N62578.AR.003146
NCBC DAVISVILLE
5090.3a

EMAIL AND ATTACHED REVISED TECHICAL MEMORANDUM AQUIFER FLUSHING AND
GROUND WATER SAMPLING ISSUES NEW WELLS AT SITE 16 NCBC DAVISVILLE RI
12/23/2008
U S EPA REGION I BOSTON MA

Technical Memorandum

NCBC Site 16 Aquifer Flushing and Ground Water Sampling Issues – New Wells

Figure 1: MW16-84D Rising Head

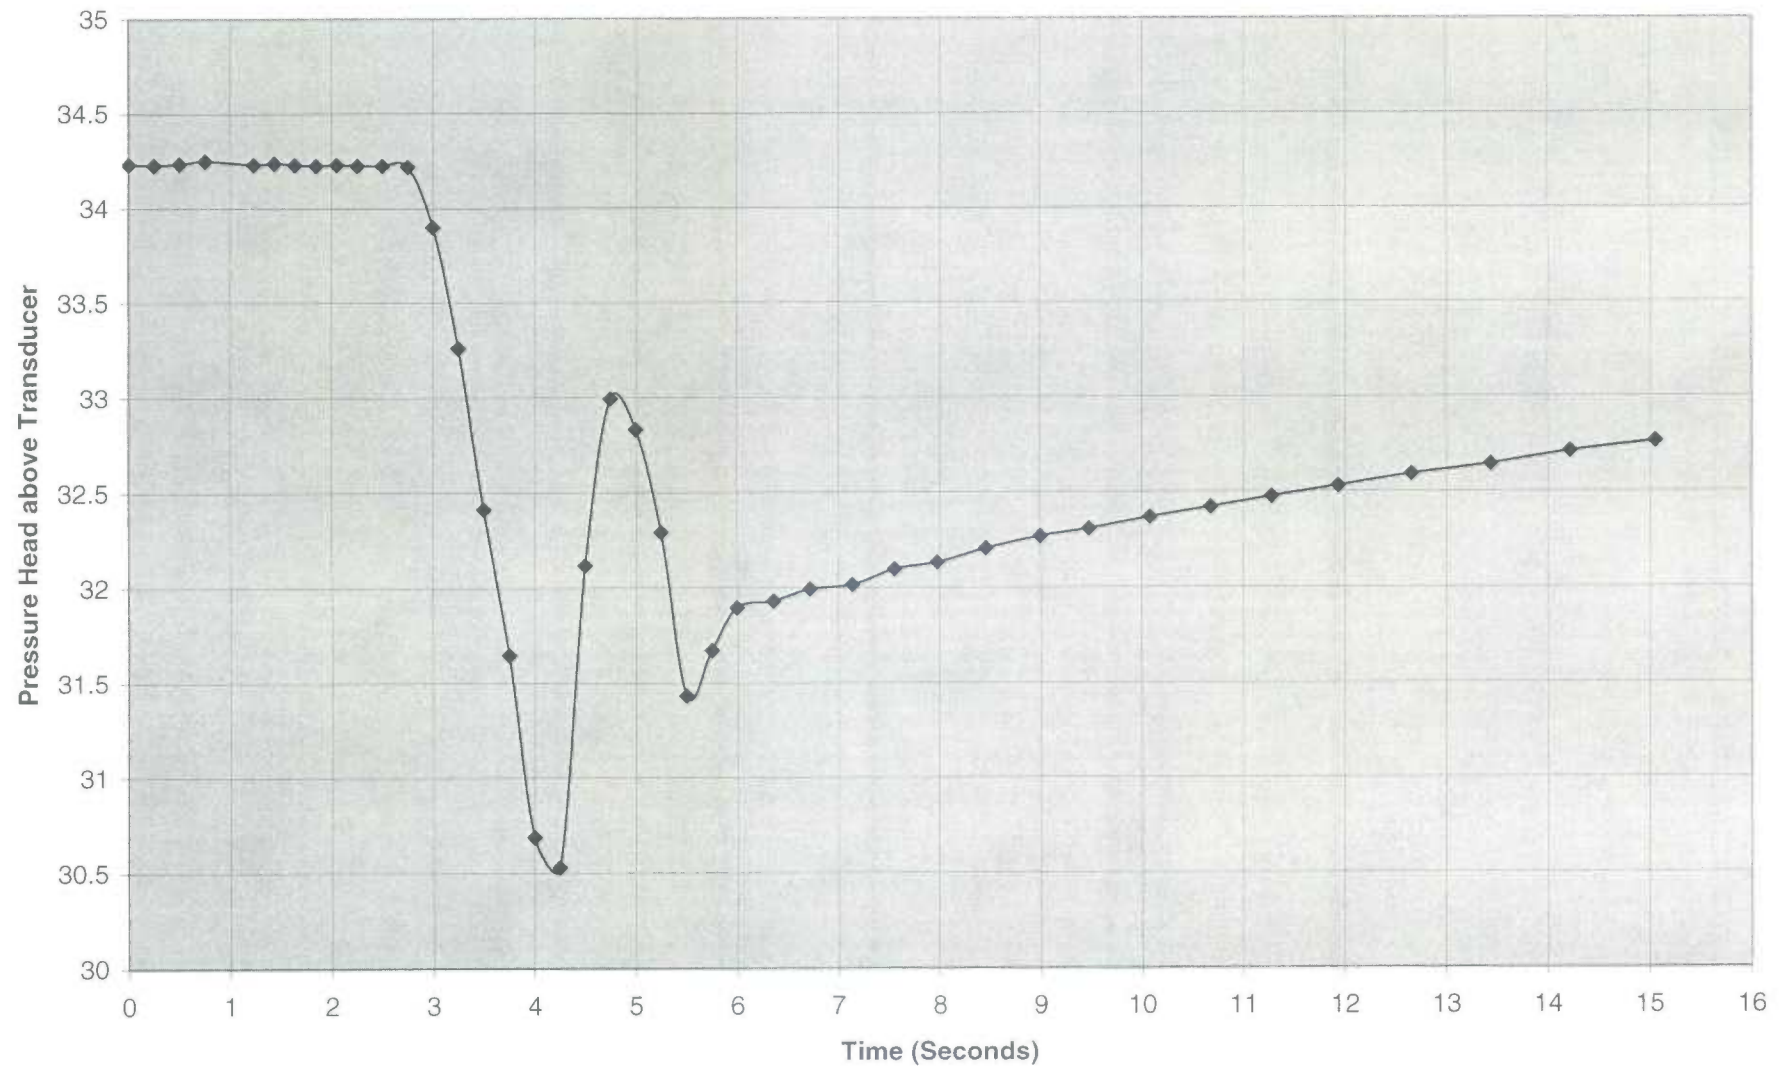
For example, this limitation is illustrated when reviewing the slug test recovery response for MW16-84D and the soil boring log description for that well where the slug test calculated hydraulic conductivity and aquifer material description suggests that the slug test and expected hydraulic conductivity are off by an order of magnitude. Figure 1 shows a two slope response for MW16-84D. While the first slope is interrupted by an oscillation there are clearly two slopes in the recovery data. The first, steeper slope, lasting 2 seconds, beginning at the 4 second mark, indicates leakage from the borehole annulus that contributes to the early recovery prior to the break in slope at around the 6 second mark. Therefore, while the second slope is shallower resulting in a lower than expected hydraulic conductivity for that well, given the aquifer materials described for the screened interval, there is also an additional impact from a leaky well/borehole annulus seal. Evaluation of the early time data for other wells also points to inadequate well seals with similar two slope recovery responses.

Figure 3. Slug Test Responses.

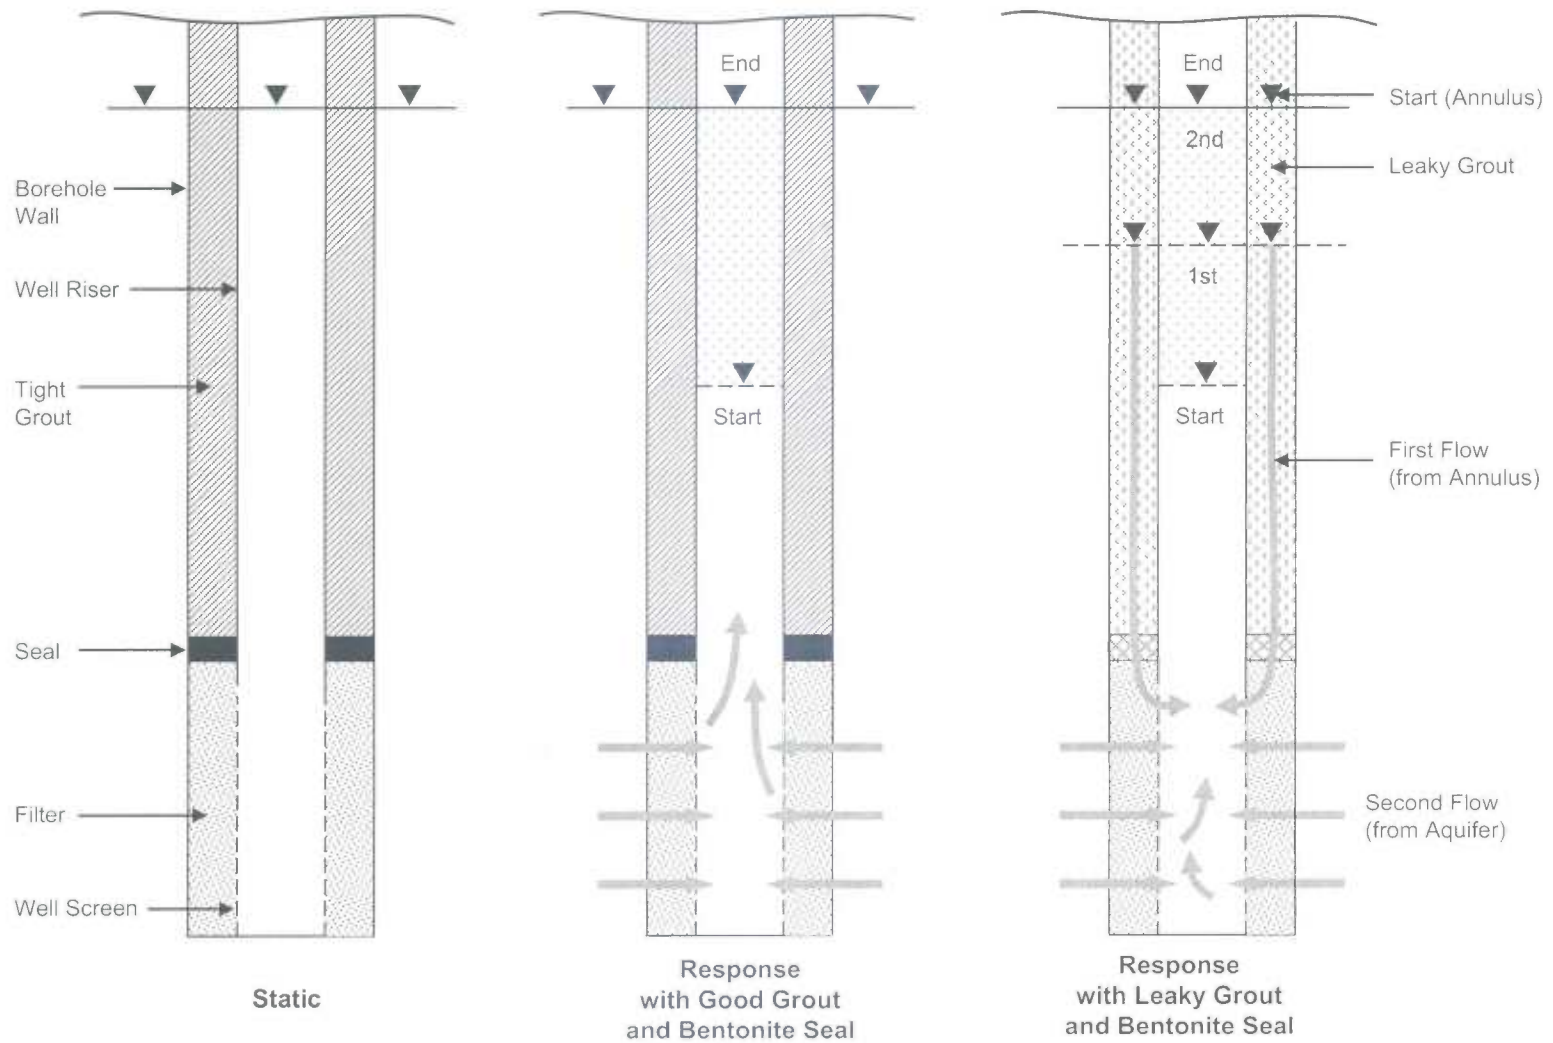
Figures 3 and 4 shows what occurs to account for the first slope and the observed wide oscillations. Figure 3 (middle) shows a monitoring well with a tight annulus seal and a leaky seal without oscillations. For a well with a tight seal, when water is withdrawn from the well there is a decline within the well casing only followed by a rise in water level within the casing back to the starting level. Ground water flows into the well from the aquifer only. When there is a leaky borehole seal (fig 3 right) as water is withdrawn from the well there is a decline within the well followed by water flowing into the well first from the relatively permeable well annulus causing a sudden rise within the well and a decline in the water level in the borehole annulus until the water levels within the well and in the annulus reach equilibrium. This accounts for the first slope observed in the early time data. The second, shallower slope will result as water subsequently rises to the initial elevation as ground then enters the well from the aquifer. Under conditions of significant “skin effect” all of the remaining recovery may result from slow drainage into the annulus with an equivalent rise in the well.

Figure 4. Oscillatory Response in Leaky Well/Borehole Annulus.

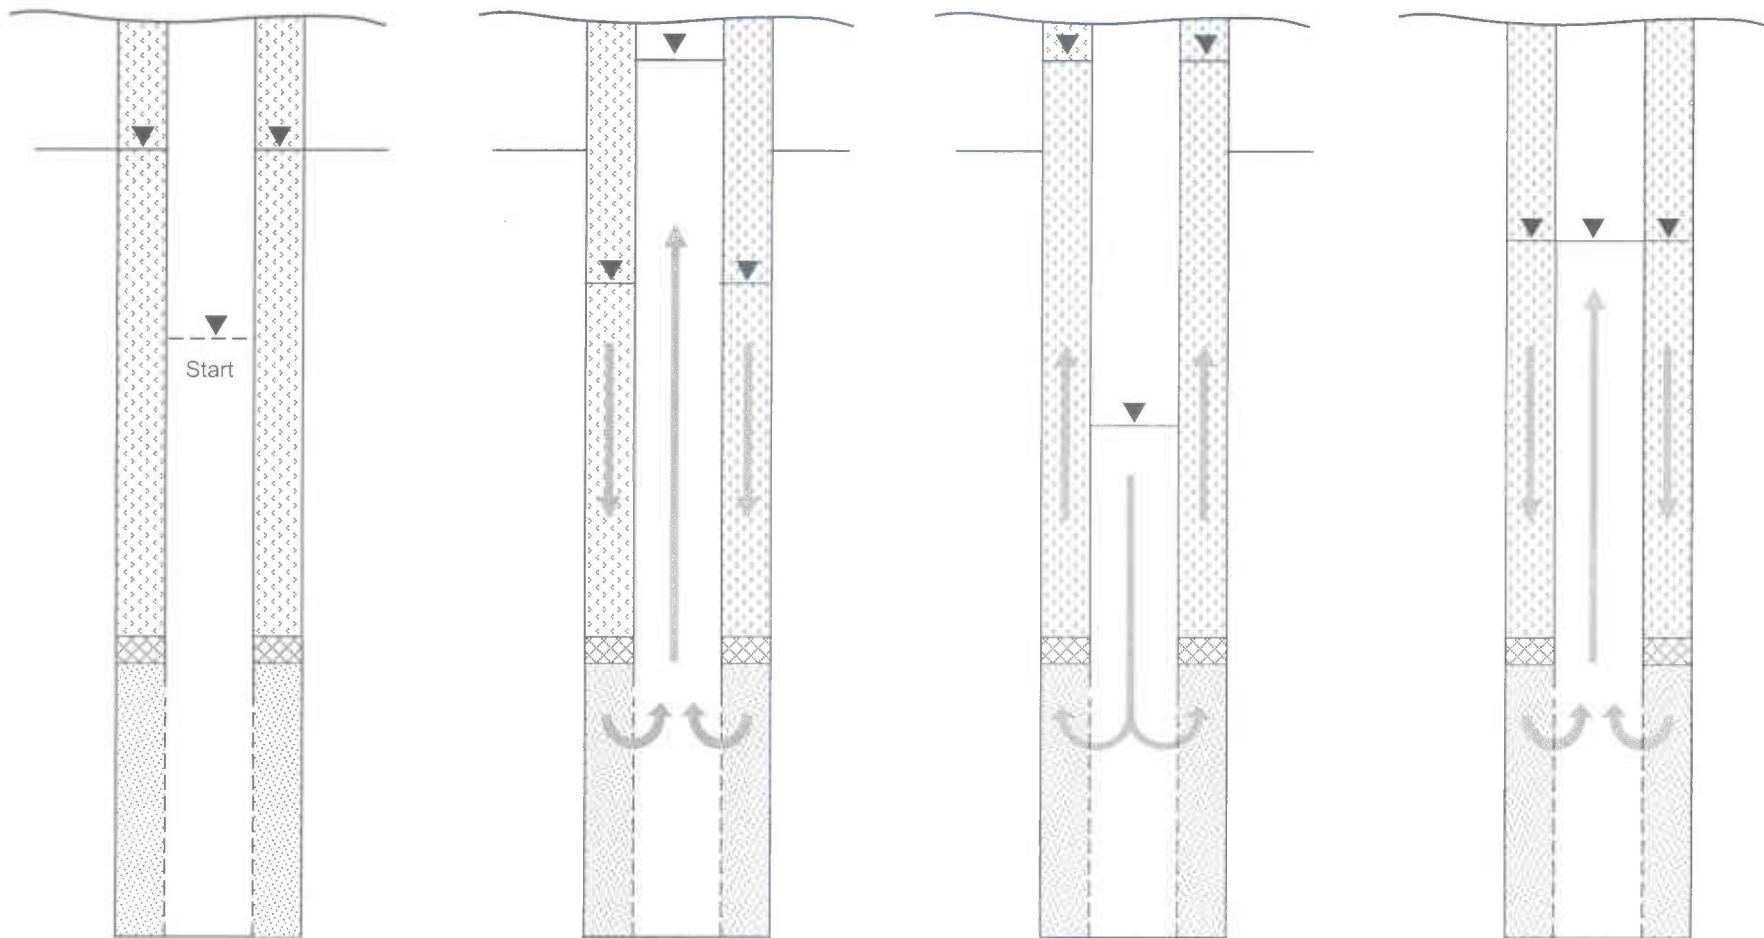
Figure 4 shows what occurs when the annulus outside of the well is filled with water as occurs when there is a double casing, or has a highly permeable annulus that can occur with sloughing of borehole wall material, bridging caused by ineffective placement of bentonite chips or pellets, filter sand, and/or secondary channels in the grout. Upon removal of water in the well, there is a surge of water into the well from the annulus

pushing the water in the well higher than the initial elevation followed by a return push back into the annulus. This cycle continues until the energy is dissipated. The number of cycles, magnitude and duration, etc. will be affected by the actual degree of permeability and channeling within the annulus.
